Product information - Toyota brake linings

8DB 355 014-881 replaces 8DB 355 013-741

New allocation of the brake pads

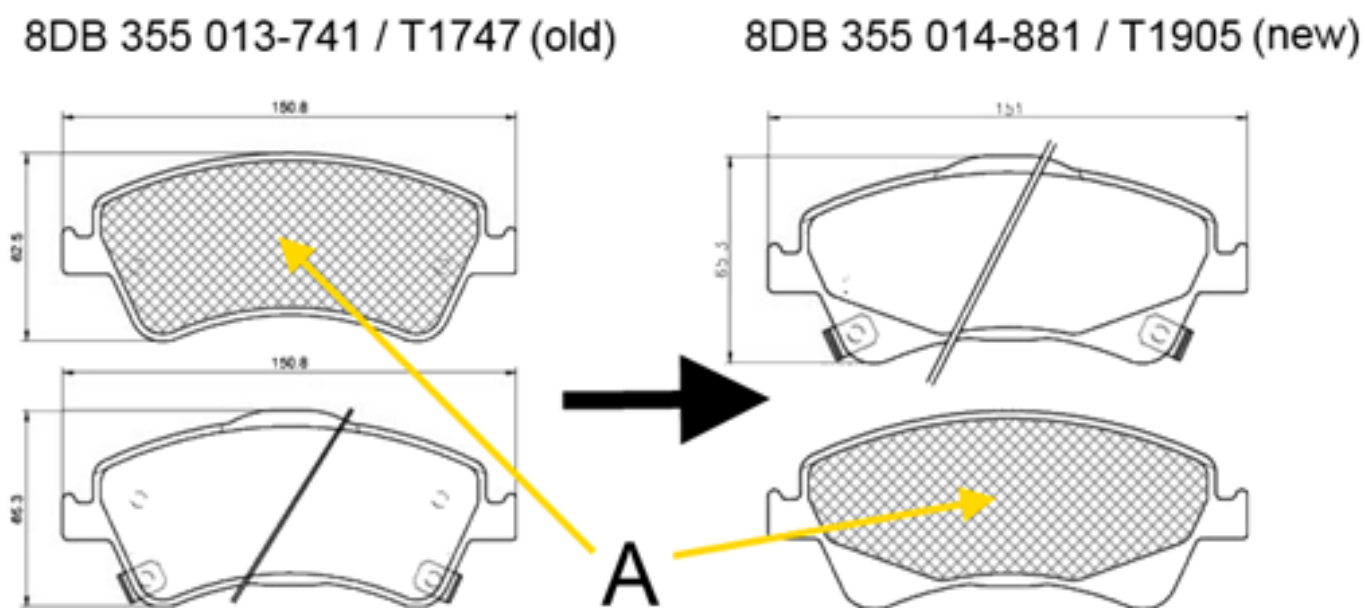
Brake pad 8DB 355 013-741 / T1747 will be replaced by brake pad 8DB 355 014-881 / T1905.

The visible difference between both brake linings is the changed shape of the friction pad (A).
